Re: WBI Energy Transmission, Inc.
Wahpeton Expansion Project
Docket No. CP22-466-000
Variance Request for Project Modification

Variance Exhibit

Wahpeton Expansion Project

Variance Request Overview

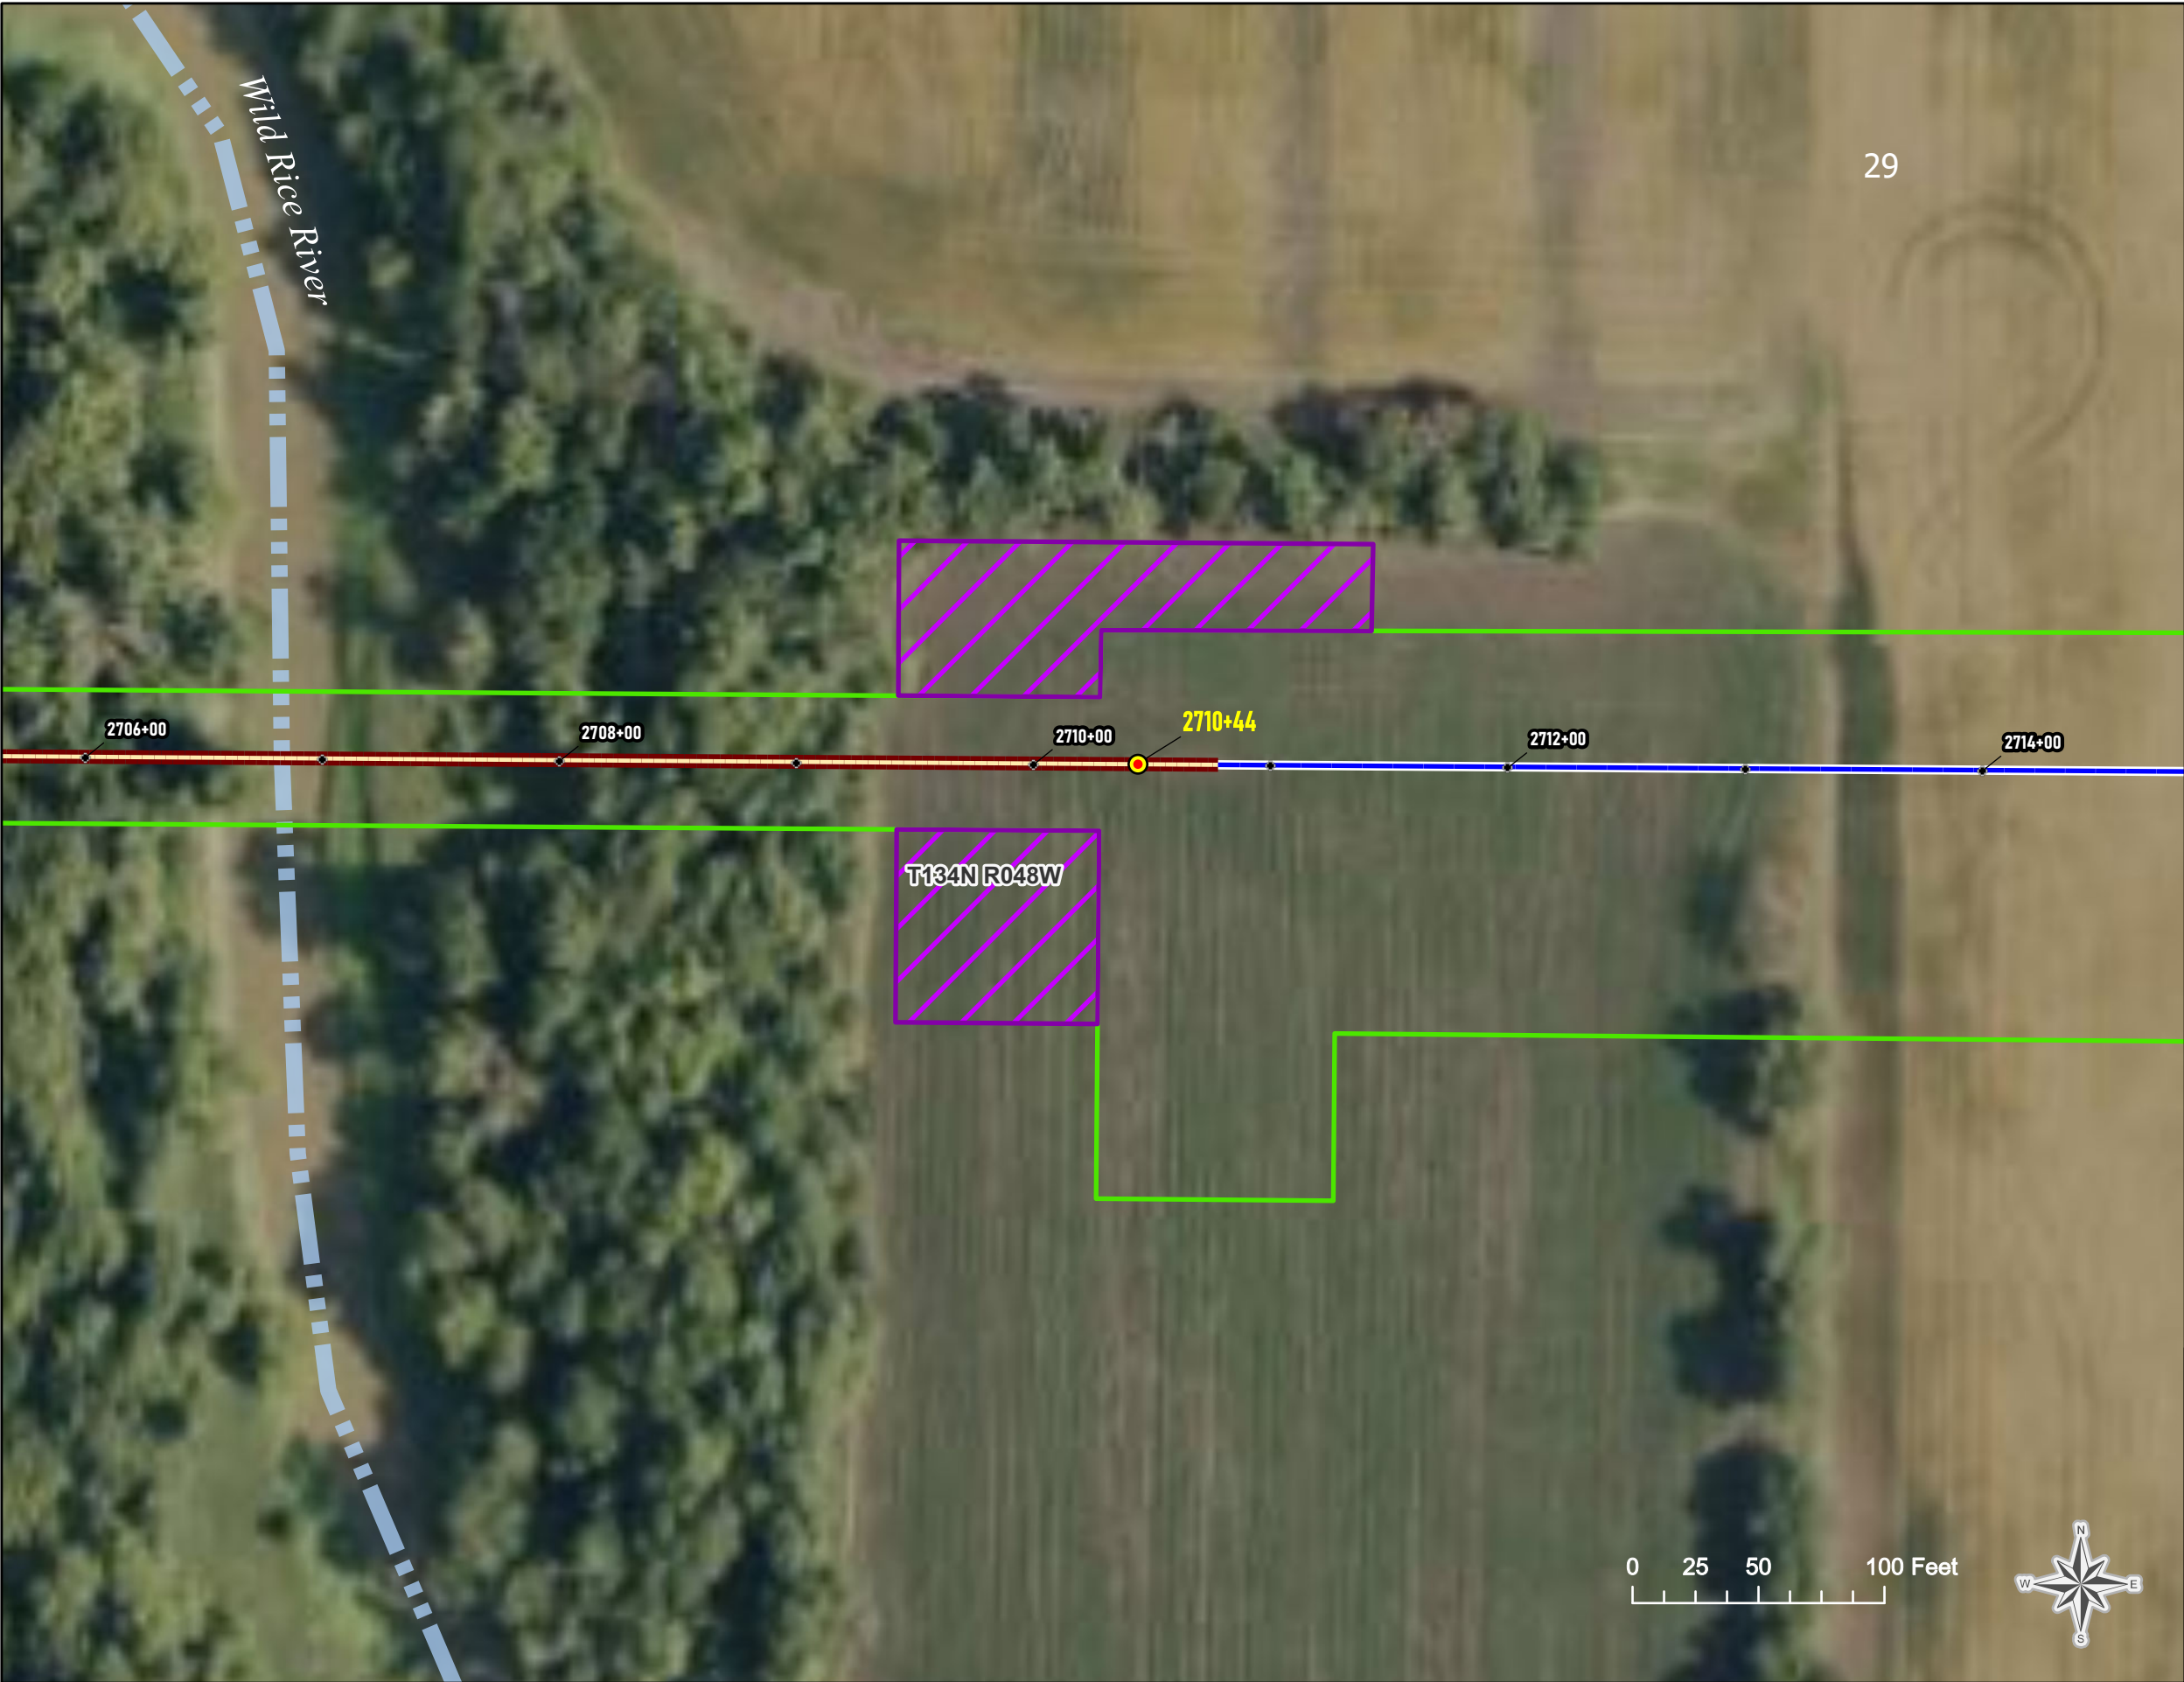
Pursuant to Environmental Condition No. 5 of the Order, WBI Energy is hereby submitting a variance request to utilize additional temporary workspace (ATWS) to safely and properly complete an anomaly investigation located near the end of the Wild Rice River HDD bore at approximate Milepost 51.35¹. An approximate 25-foot-deep excavation will be required to expose and conduct an anomaly investigation of the bore pipe. WBI Energy is requesting ATWS to allow sufficient storage space for topsoil and subsoil separation and to provide adequate space to safely operate equipment.

This modification, as depicted in Attachment A, will result in approximately 0.33 acre of additional temporary disturbance and have no change in operational impacts. The ATWS is located entirely within agricultural lands in Richland County, North Dakota and no wetlands/waterbodies, cultural resources, or other environmental resources will be impacted by this Project modification. Additionally, WBI Energy will implement the mitigation measures in FERC's Upland Erosion Control, Revegetation, and Maintenance Plan and other permits/plans as applicable to further reduce impacts.
